## **Appendix 1-C: Agency and Stakeholder Consultations**

**RE: Request for Cultural Resources Review for the Champlain Hudson Power Express Project (Project) – Harlem River Segment 20A – Harlem Bulkhead Penetration and Tie-in change of Area of Potential Effect (APE) (OPRHP# 09PR03910)**

Re: DOE  
Champlain Hudson Power Express/TDI/Underwater HVdc Transmission Line  
09PR03910

Re: *Champlain Hudson Power Express (CHPE) Project – Harlem River Bulkhead Penetration and Tie-in (EM&CP Segment 20A)*  
*Borough of the Bronx, Bronx County, NY*

PROJECT: CHAMPLAIN HUDSON POWER EXPRESS PROJECT		
TITLE: SEGMENT 20A HARLEM BULKHEAD PENETRATION AND TIE-IN LOCATION MAP		
DRAWN BY: A. YOUNG	PROJ. NO.: 490523.0007.0000	
CHECKED BY: K. MACK	FIGURE 1	
APPROVED BY: K. MACK		
DATE: APRIL 2024		
		P.O. BOX 1068 BATH, ME 04530
FILE:	CHPE

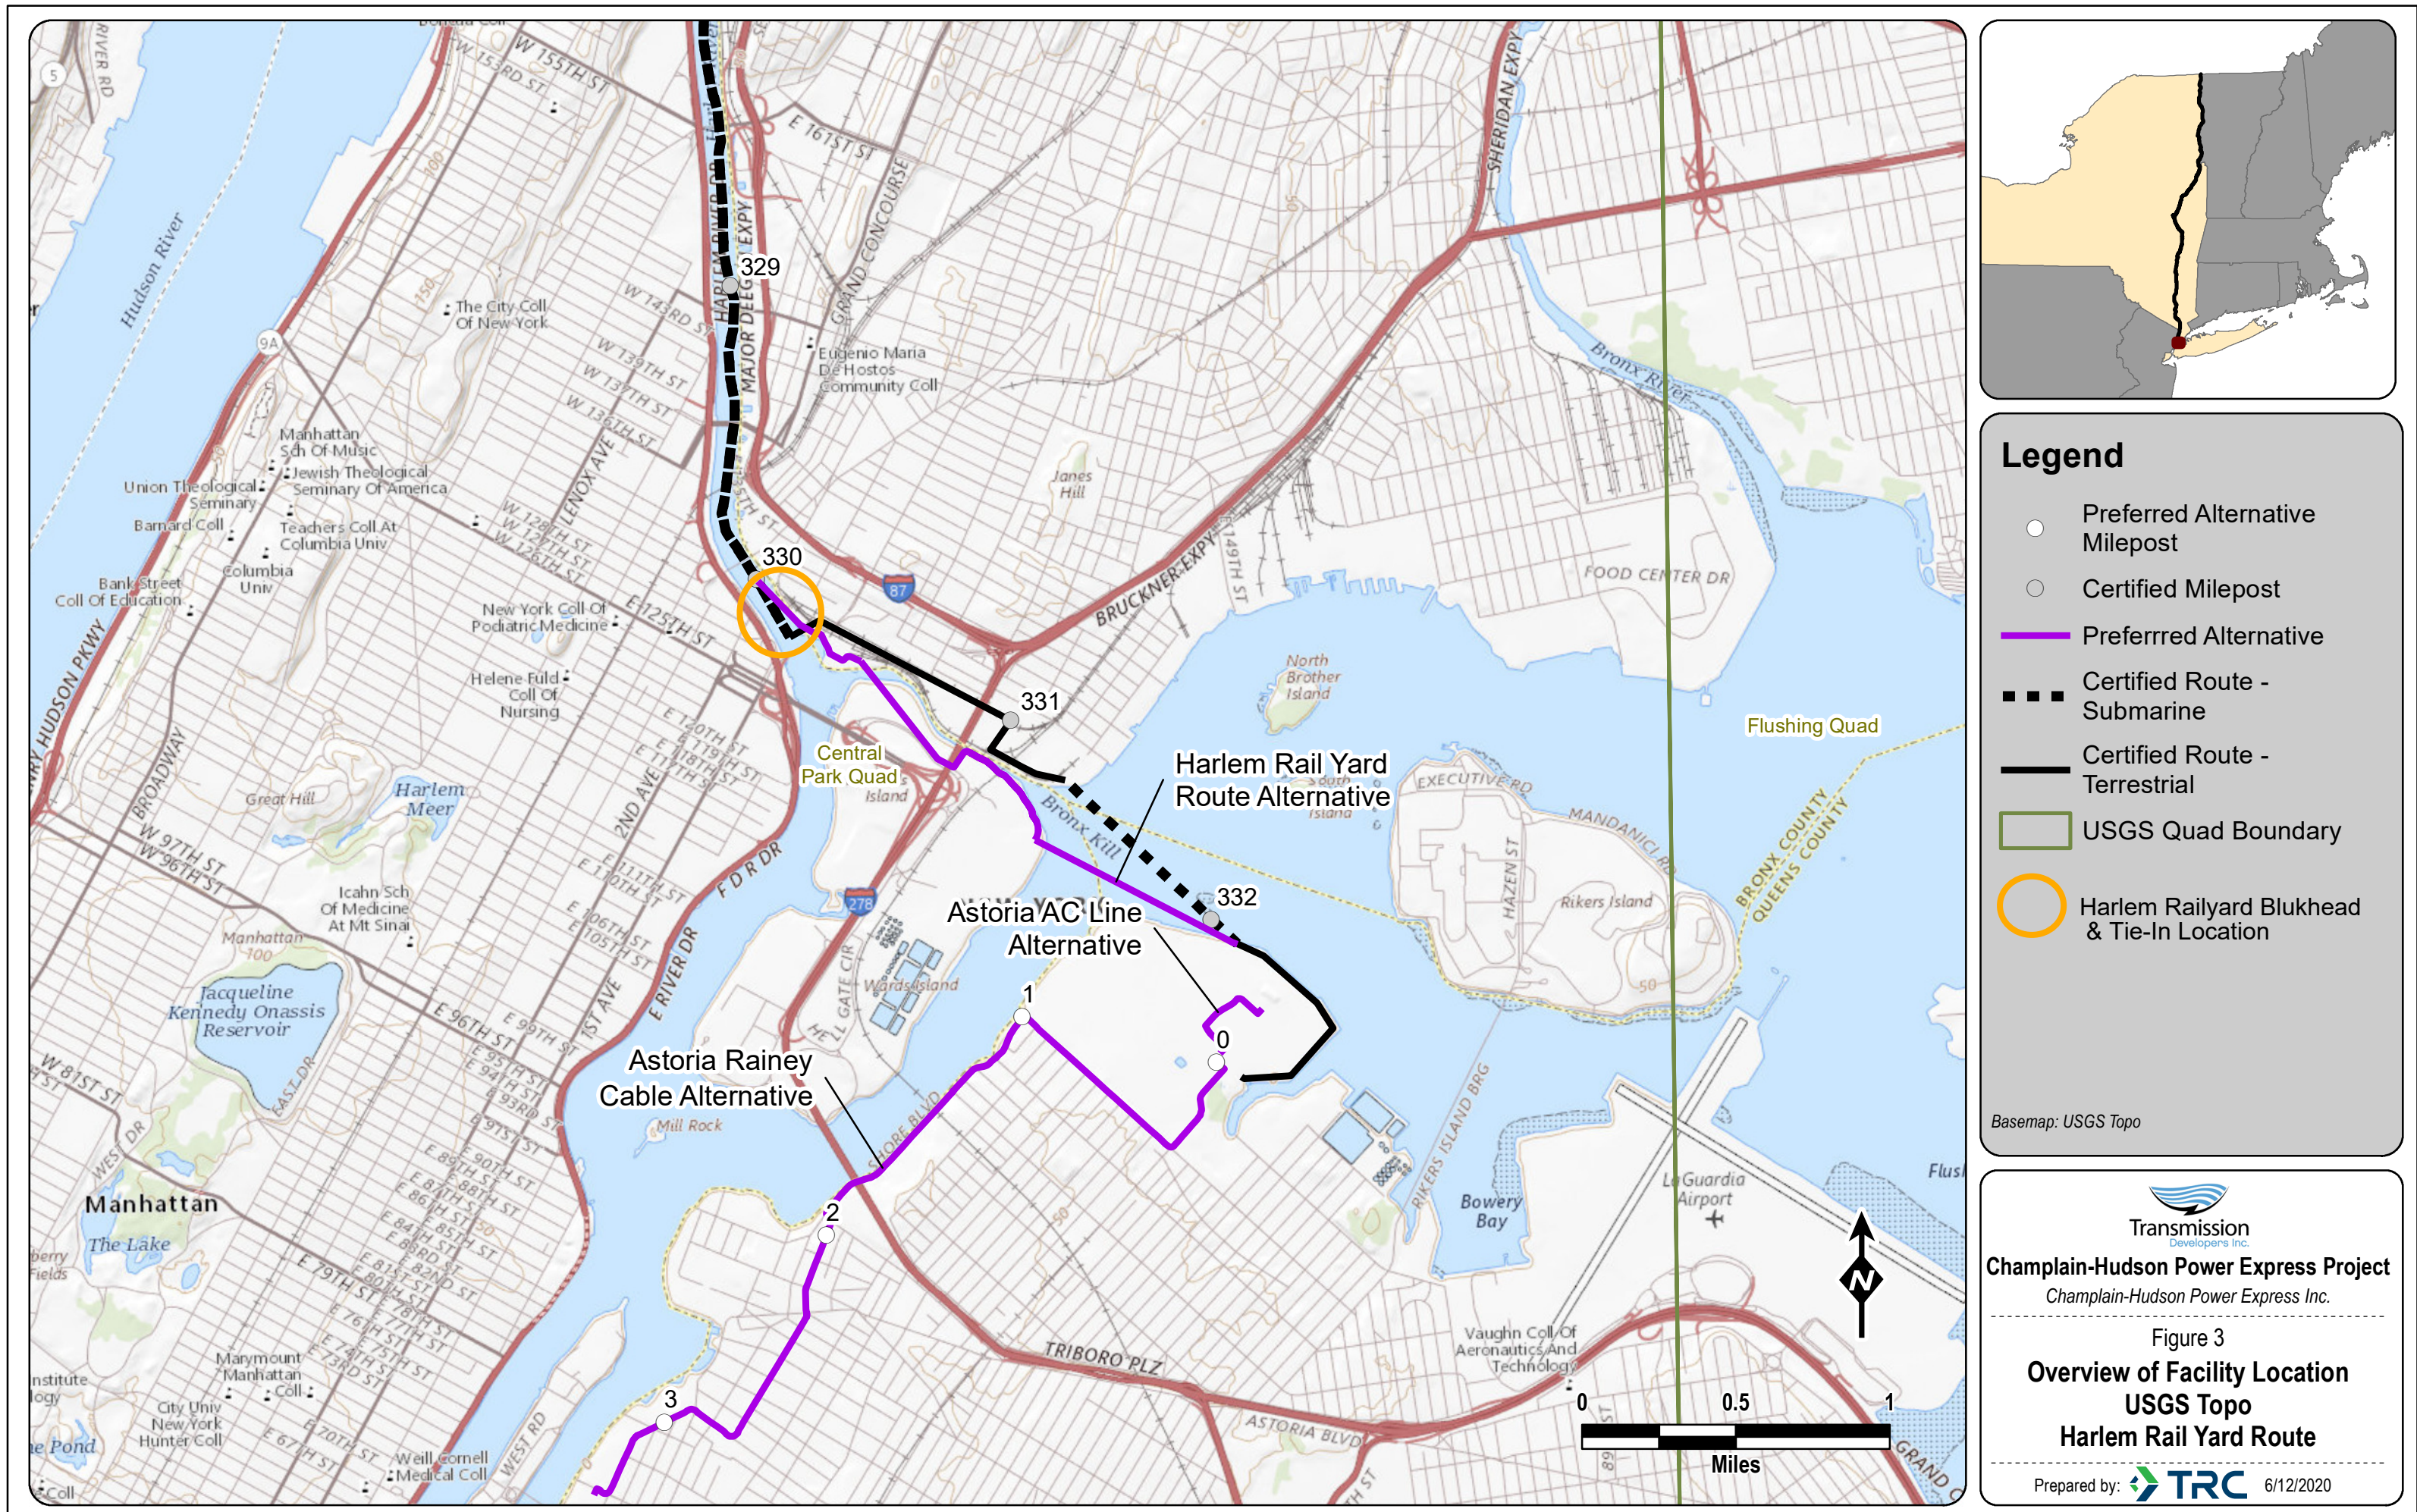
The proposed Harlem Bulkhead Penetration and Tie-in is currently located on the east side of the Harlem River immediately north of the Willis Avenue Bridge (Figure 1) along the Harlem Rail Yard Route or Segment 20A of the overall CHPE Project. The previous cable landfall location was also on East side of the river but immediately north of the current location (Figure 2). For an unrelated development, in February of 2022 the McLaren Engineering Group prepared a Permit Application for shoreline stabilization in this vicinity. They consulted with the State Historic Preservation Office (SHPO) and their report contained a copy of letter from SHPO dated September 3, 2021 stating that “[B]ased upon this review, it is the opinion of the New York SHPO that no historic properties, including archaeology and/or historic resources, will be affected by this undertaking.”

SHPO has reviewed the *Request for Cultural Resources Review for the Champlain Hudson Power Express Project (Project) – Harlem River Segment 20A – Harlem Bulkhead Penetration and Tie-in change of Area of Potential Effect (APE)* (TRC, 5/3/24). We concur with TRC's recommendation that that no further archaeological studies are needed for the current proposed location of the Harlem Bulkhead Penetration and Tie-in.
